Borde Hill Stables

*Planning Amendment
Supporting Statement*

This document has been prepared to support proposals to amend planning permission DM/23/3210 (Variation of condition no. 2 relating to planning application DM/23/0421 - to amend the approved plans to include revisions to the design of the extension, increased soft landscaping and reduction in hard landscaping, and modest increase in size of the external plant room (Amended plans received 21 March 2024)) to amend the external plant room to the north of the stables to accommodate a UKPN substation in lieu of the biomass boiler and battery storage.

Consented Ground Floor Plan - DM/23/3210

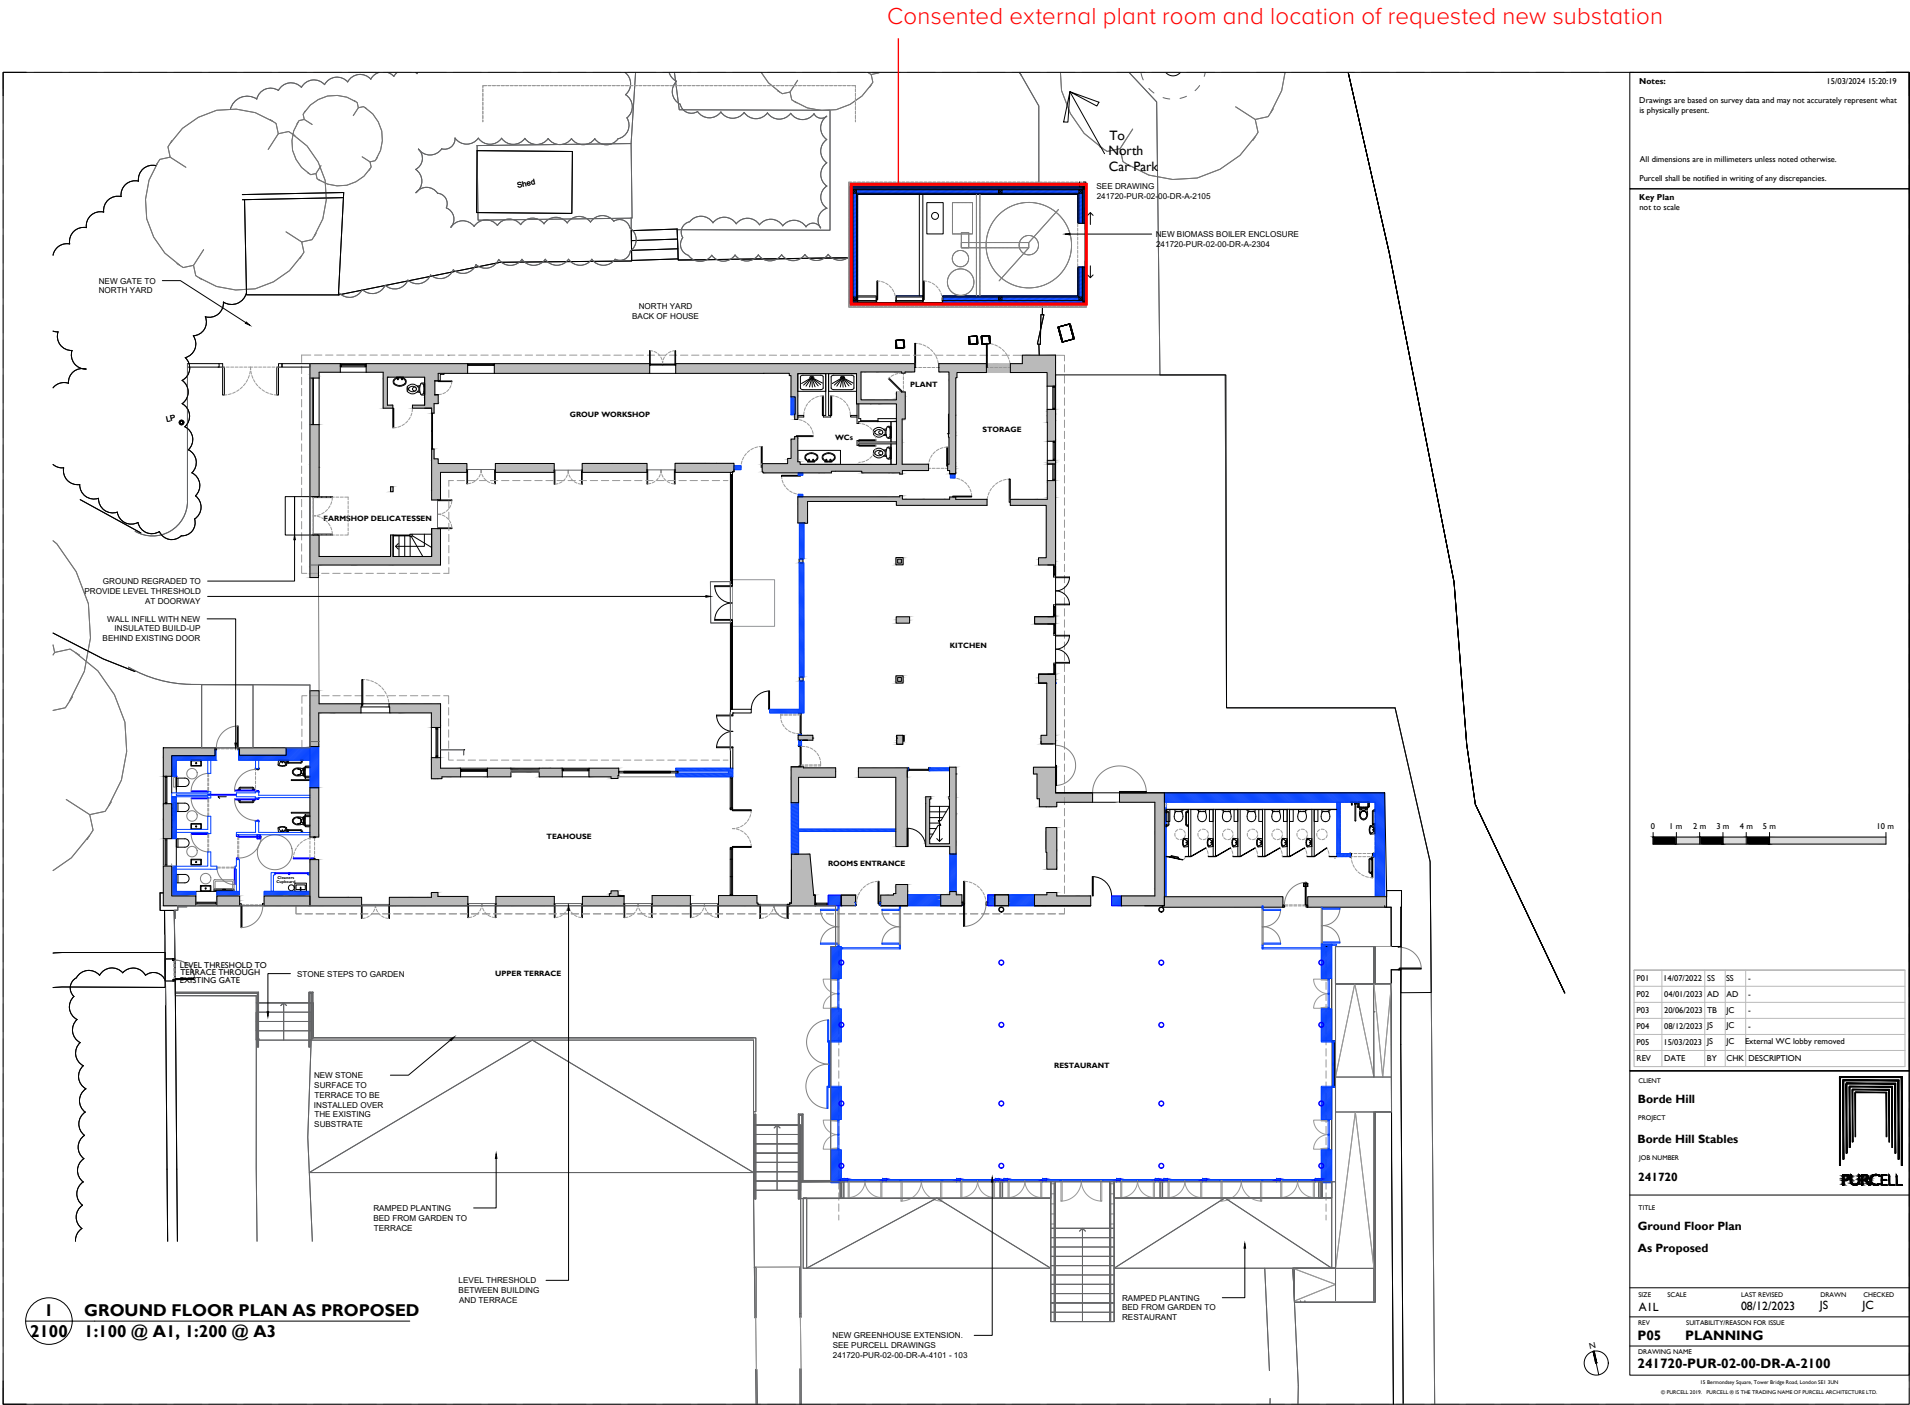
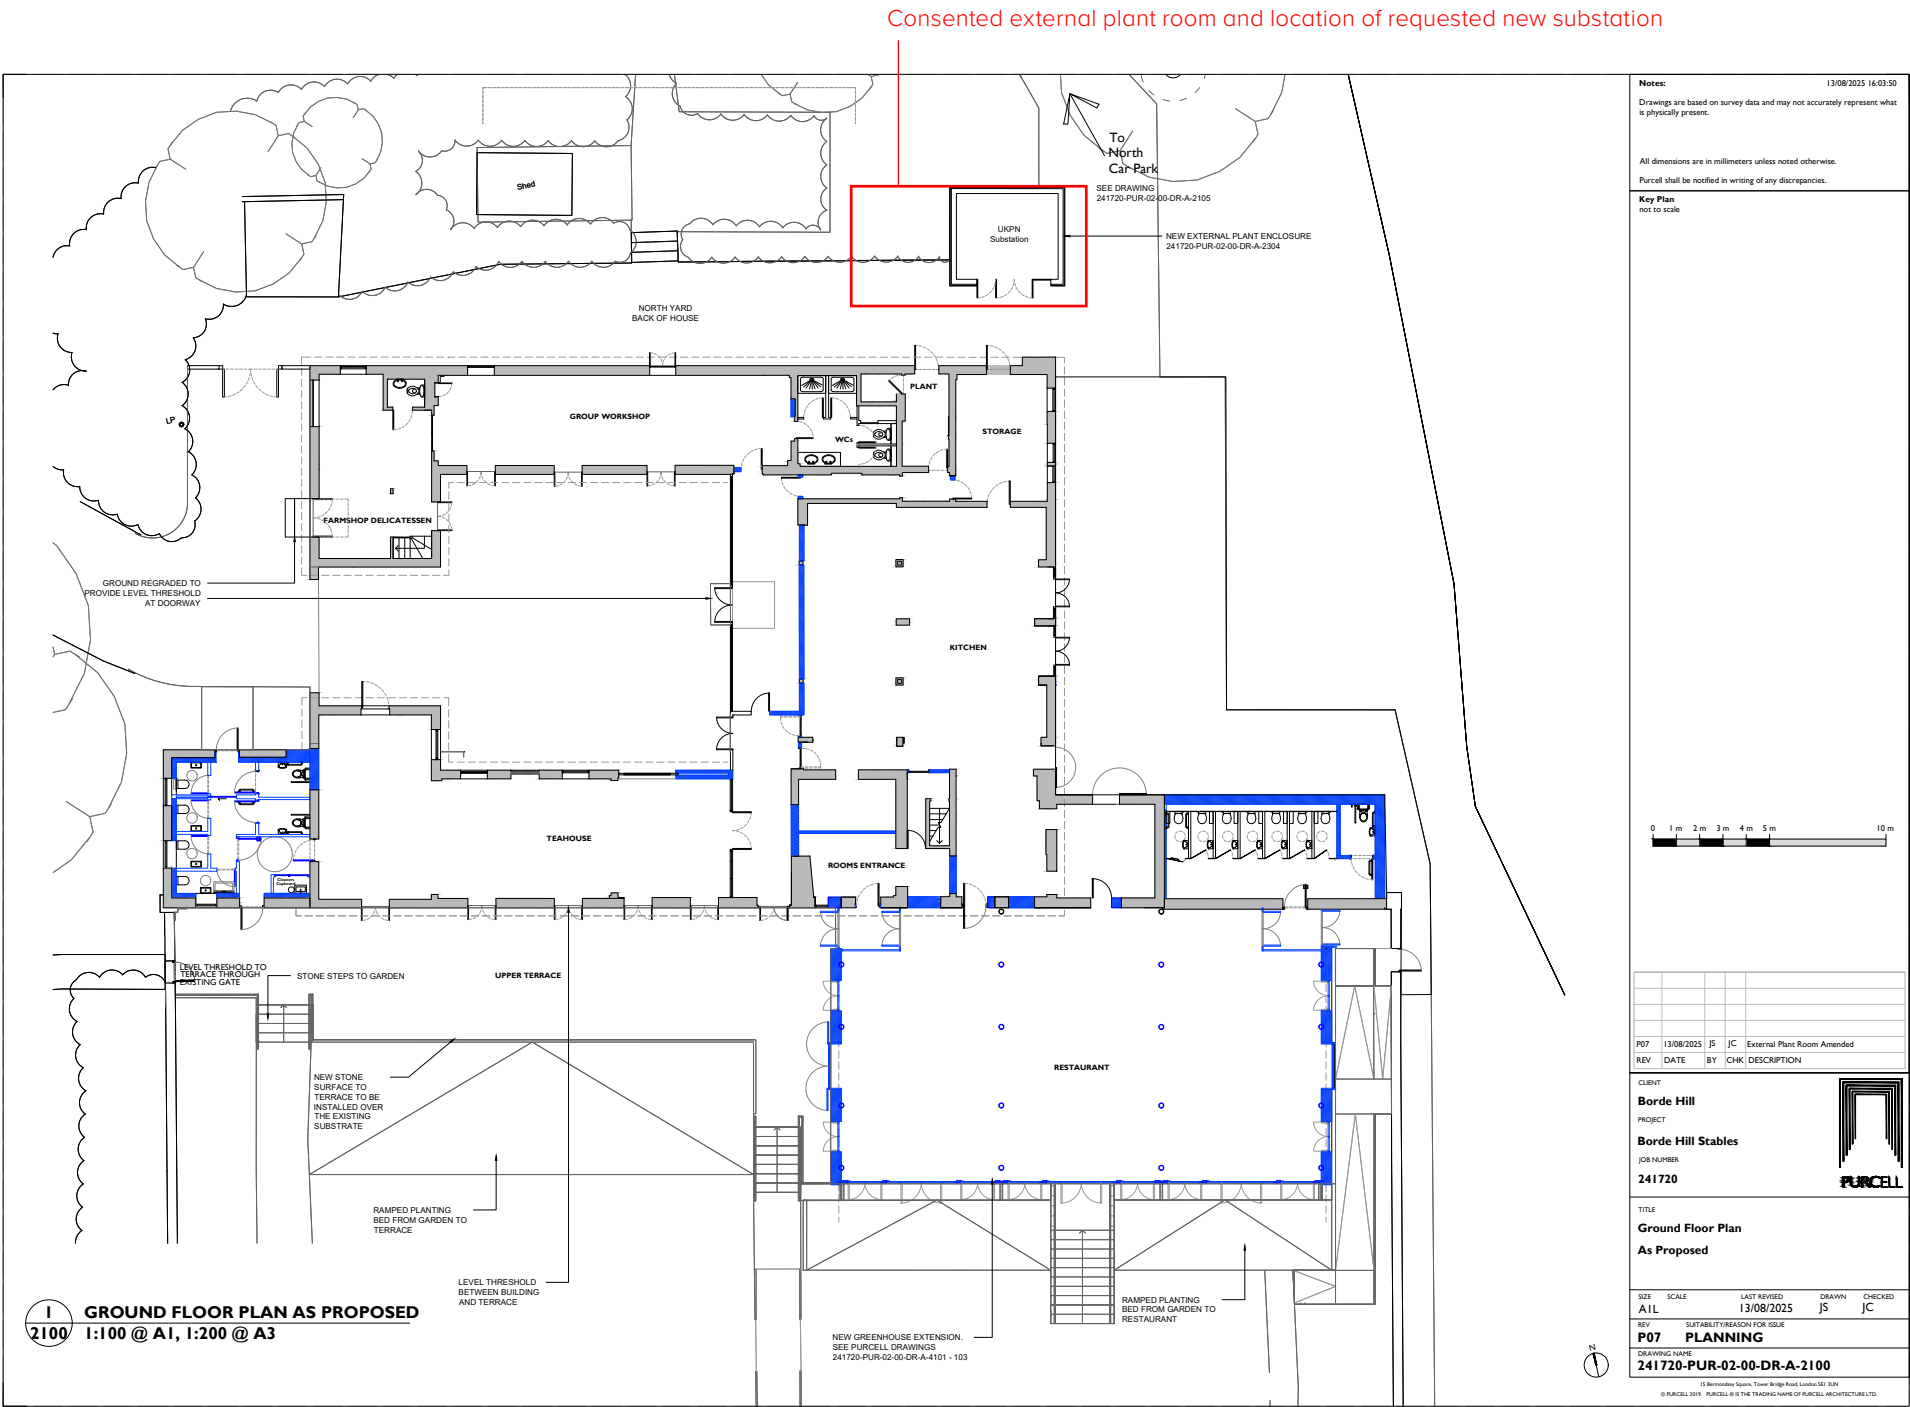
The location of the consented biomass boiler to the North of the site works well as a location for the substation as it is not located near any front of house spaces and is shielded from the car park by vegetation.

Given the requirement for a new substation to service the development, the battery storage is no longer required due to the higher capacity of the network. The full extent of the external plant room can therefore be re-purposed and used as the location for the substation. A revised energy statement has been submitted as part of this application which demonstrates the development’s compliance with the following local planning policy and statutory guidance:

Amended Ground Floor Plan

Approved Plan - DM/23/3210

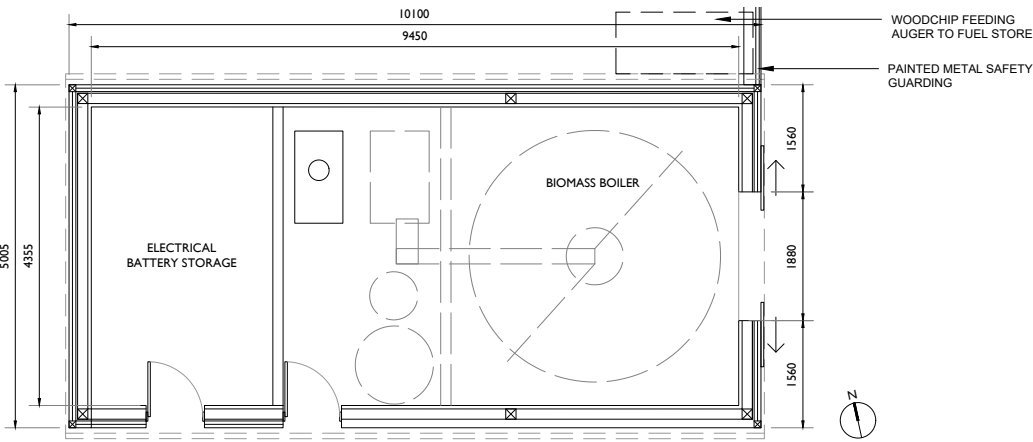
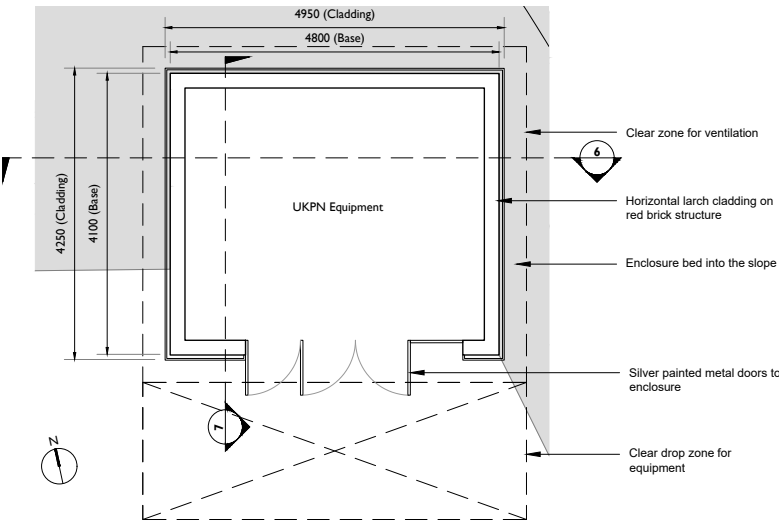
To minimise any additional impact on the Registered Park and Garden, the consented design has been matched where possible to minimise change. The footprint of the external plant room will be reduced by 40% when compared to the consented scheme to 4.95m wide by 4.25m deep. The requirement for a blast proof roof for safety reasons has resulted in a minimal concrete flat roof design. The height of the walls has been reduced to 3.25m, and therefore the resulting form is substantially less than the approved massing.

Amended Plan

Approved East Elevation - DM/23/3210

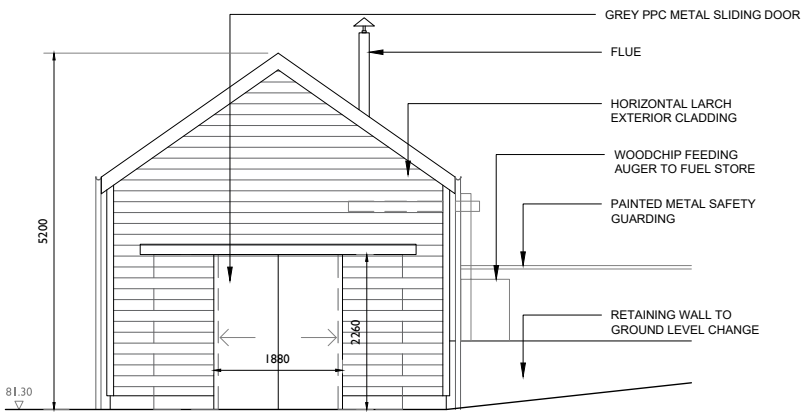
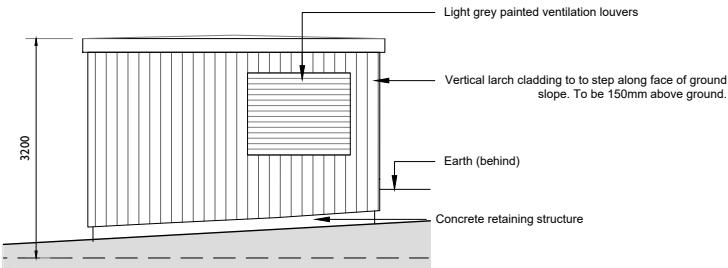
The brick walls and concrete retaining structure will remain clad in natural larch to blend the plant room in with the trees and match the WC block elevation. Grey painted metal doors and louvres will provide secure access to the enclosure and ventilation to the equipment inside. The exposed edge of the concrete roof has been reduced to 200mm, and will blend in with the cladding once the large has silvered over time.

Amended East Elevation
